**TOWN OF WINTER PARK
PLANNING COMMISSION
Tuesday, April 9, 2024 8:00 AM**

TO Planning Commission
FROM Hugh Bell, Planner
THROUGH James Shockey, AICP, Community Development Director
DATE April 9, 2024
RE Exemption Plat – 265 Lake Trail – Amended Lot 4, Elk Run of Winter Park Subdivision,
Filing 1 (PLN24-015)

TO Planning Commission
FROM James Shockey, AICP, Community Development Director
DATE April 9, 2024
RE PUBLIC HEARING: Major Site Plan – 820 Ski Idlewild Road – Idlewild Park – Tract A, Rendezvous at Winter Park Sub Ex No. 2 and Tract A, Idlewild Sub Ex No. 1 (PLN23-115)

SHEET TITLE:
IDLEWILD PARK
PHOTOMETRIC PLAN

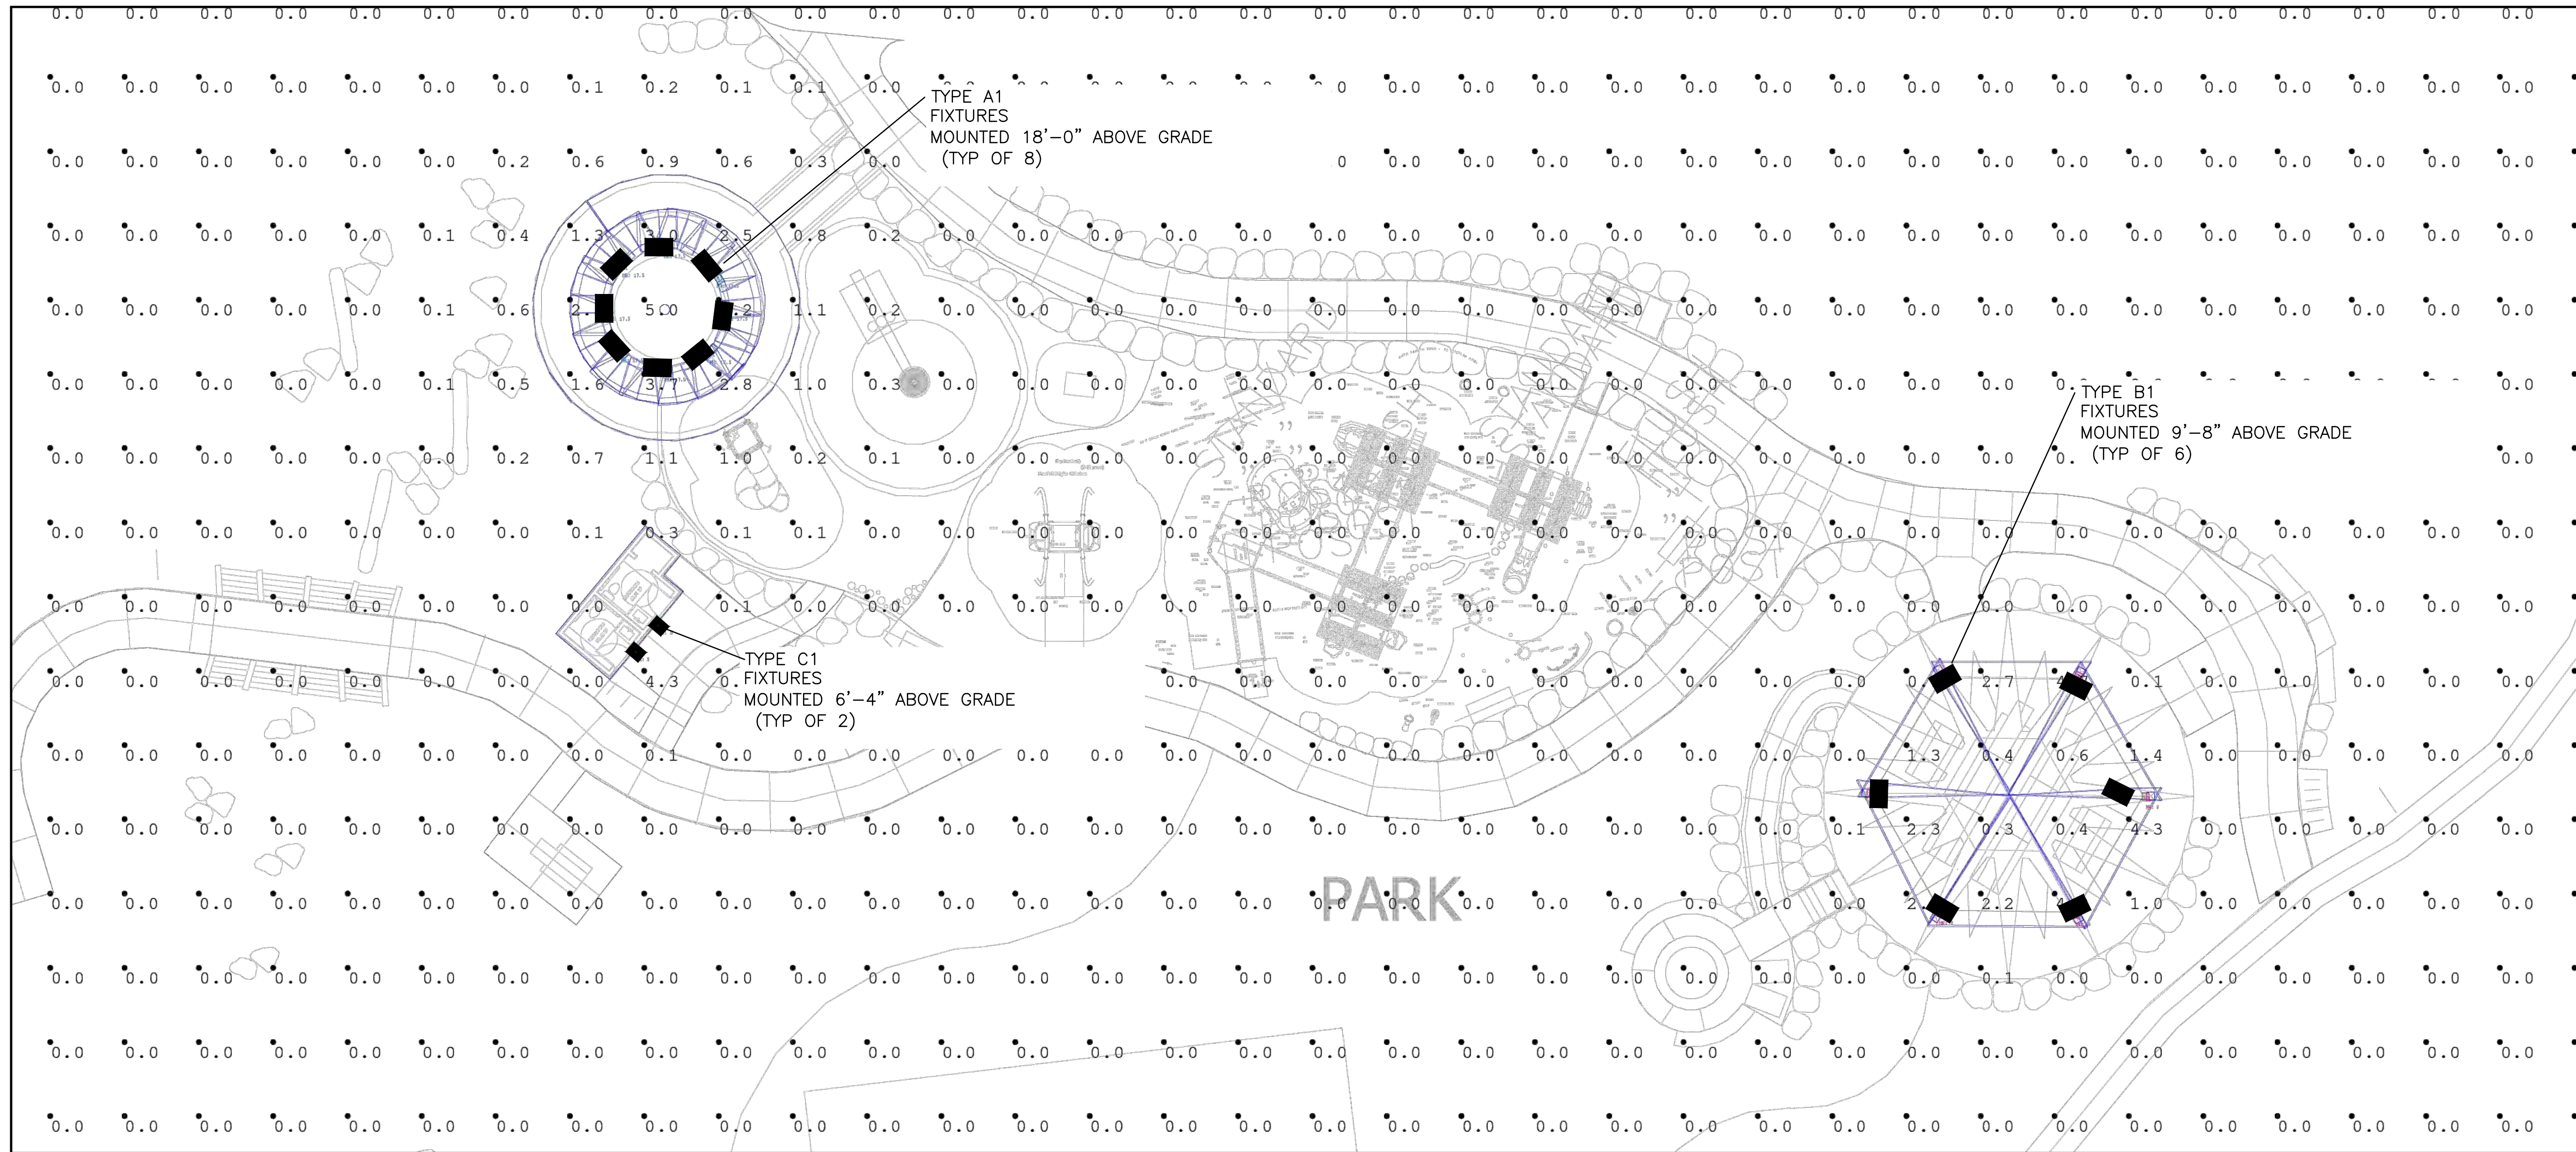
Partially satisfactory. Three (3) fixtures are proposed, and all contain the International Dark Sky Association (IDA) approval stamp as required in Article 3.K, Outdoor Lighting. Each fixture is limited to 1,500 lumens and shall have a BUG (backlight, uplight, and glare) Rating that doesn't exceed B1 U0 G1. Staff is unable to determine the BUG rating as manufacturer specification sheets were not provided.

Photometric plans are required for nonresidential and multifamily projects. The Applicant submitted a compliant photometric plan.

Fixture Name	Proposed # of Fixtures	Proposed Lumens per Fixture	Total Proposed Lumens	Proposed CCT
Jett Outdoor Wall Sconce	6	693	4158	2700K
VOLT 12" LED Hardscape Light	8	693	?	2700K
6" Round Direct Ceiling/Wall Mount Light	2	519	?	?

- Applicant shall submit manufacturer specification sheets for outdoor lighting fixtures as required in § 3-K-4, Non-Residential and Multifamily Lighting Requirements.
- Applicant shall indicate BUG ratings for each fixture.
- Applicant shall update the Outdoor Lighting Tabulation on the Major Site Plan Application Form.

1. Applicant shall submit manufacturer specification sheets for outdoor lighting fixtures as required in § 3-K-4, Non-Residential and Multifamily Lighting Requirements.

2. Applicant shall indicate BUG ratings for each fixture.
3. Applicant shall update the Outdoor Lighting Tabulation on the Major Site Plan Application Form.
